RAI Volume 3, Chapter 2.2.1.3.9, First Set, Number 2:

Justify the assumption, implicit in the SAR, that groundwater flow paths under future climates and associated water table rise can be characterized using the same fate and transport characteristics as those under current conditions.

Figure 1. Corrected Breakthrough Curves for Nonsorbing Radionuclides for Future Glacial-Transition Climatic Conditions Using Three Alternative Methods

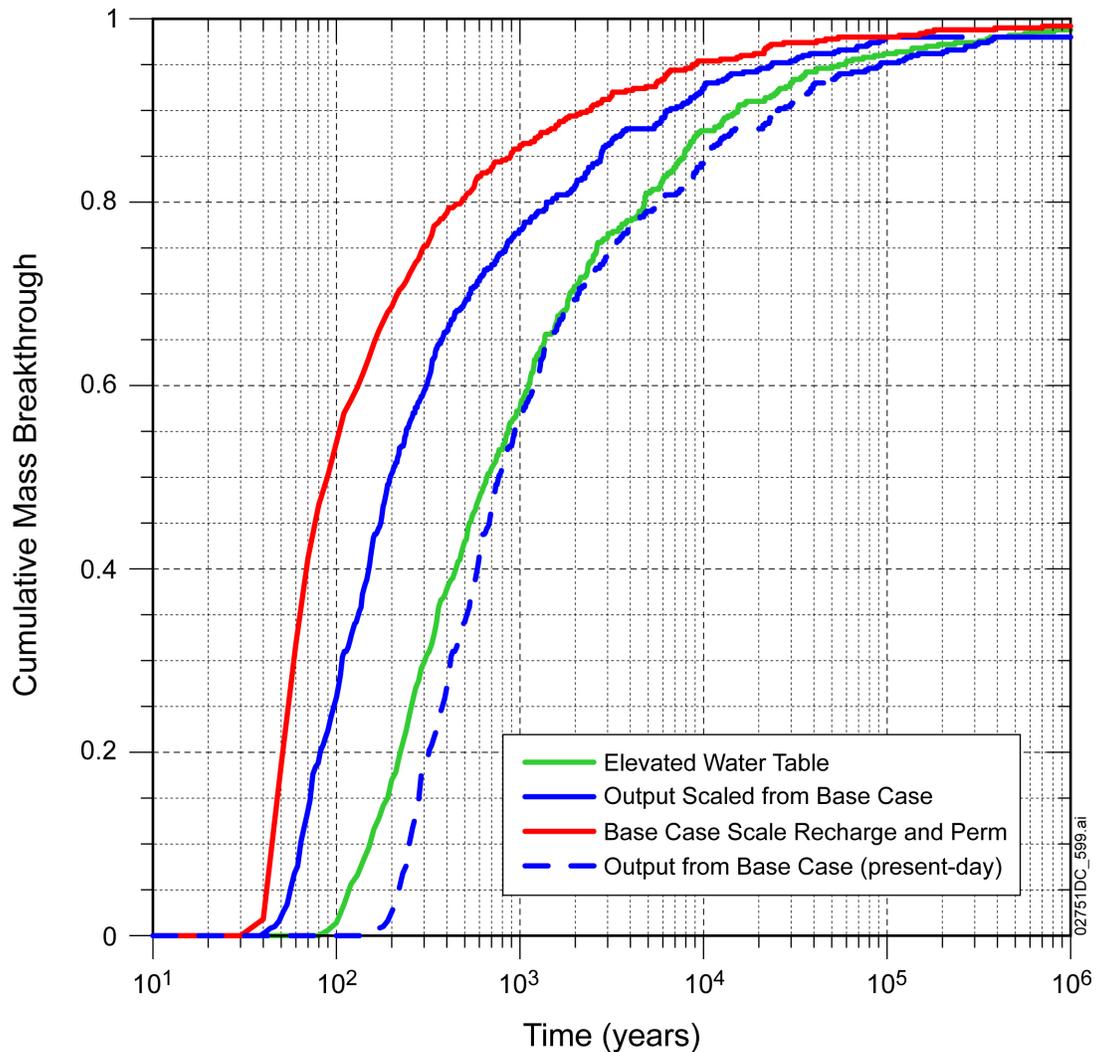
Basis: The applicant states that climate change is implicitly and conservatively included in the site-scale saturated zone transport model by increasing flow rates without raising the water table or changing flow paths (SAR p.2.3.9-83). The applicant states that particle tracking simulations incorporating the water table rise (effect of climate change) produce longer simulated transport times because some transport occurs in lower permeability units.

Staff requires confirmation and justification of the assumption that these longer flow paths through lesser permeability units can be represented using the same geochemical assumptions and data as the more permeable units to evaluate compliance with 10 CFR 63.114(a)(1-3).

Revised analyses of the alternative methods of modeling the glacial-transition climatic conditions have been performed to correct the breakthrough curves in *Site-Scale Saturated Zone Transport* (SNL 2008a, Appendix E). The revised results are plotted as Figures 1 and 2 for nonsorbing radionuclides and neptunium, respectively. The red and green curves plotted on these figures are corrected from the previous results (SNL 2008a, Figures E-1 and E-2), while the blue curve is not affected by the error. The dashed blue curve on these figures represents the present-day climate base-case results (SNL 2008a, Section 6.7).

The corrected red curve on these figures represents the case where the permeability of all the hydrostratigraphic units and vertical recharge rates are increased by a factor of 3.9 above the base-case values, with the same boundary heads used as in the present-day climate case. This case reflects an increased specific discharge along the expected travel paths from the repository to the accessible environment of a factor of 3.9, the ratio of the saturated zone groundwater fluxes for the glacial-transition climate state to the present-day climate state derived from the Death Valley regional flow model (SNL 2008b, Table 6-4[a]). This is the same approach and

The corrected green curve on these figures represents the case where the water table is raised and the vertical recharge increased by a factor of 3.9. In this case, the present-day water table is raised by 20 m in locations with a present-day water table elevation of 700 m, 50 m in locations with a present-day water table elevation of 740 m, and 100 m in locations with a present-day water table elevation of 1,000 m, with other locations assigned a water table rise calculated by linear interpolation or extrapolation, as suggested in *Saturated Zone Site-Scale Flow Model* (SNL 2007, Section 6.6.4.2). This case represents an expected rise in the water table combined with an increase in the vertical recharge to the saturated zone associated with the glacial-transition climate state.

The corrected results presented in Figures 1 and 2 illustrate that the scaled recharge and permeability method (red curve), which increases the specific discharge fluxes throughout the modeled domain by a factor of 3.9, provides the shortest transport times from the repository to the accessible environment, and is therefore conservative from a performance perspective. The results from the scaled recharge and permeability method (red curve) indicate a shorter transport

The corrected results indicate that raising the water table in the method suggested in *Saturated Zone Site-Scale Flow Model* (SNL 2007, Section 6.6.4.2) (green curve) has a slight effect on the predicted mass breakthrough from the base-case present-day climatic conditions case (dashed blue curve). This is a result of the small change from the present-day hydraulic gradient downgradient from the repository associated with the applied boundary condition changes in this elevated water table case.
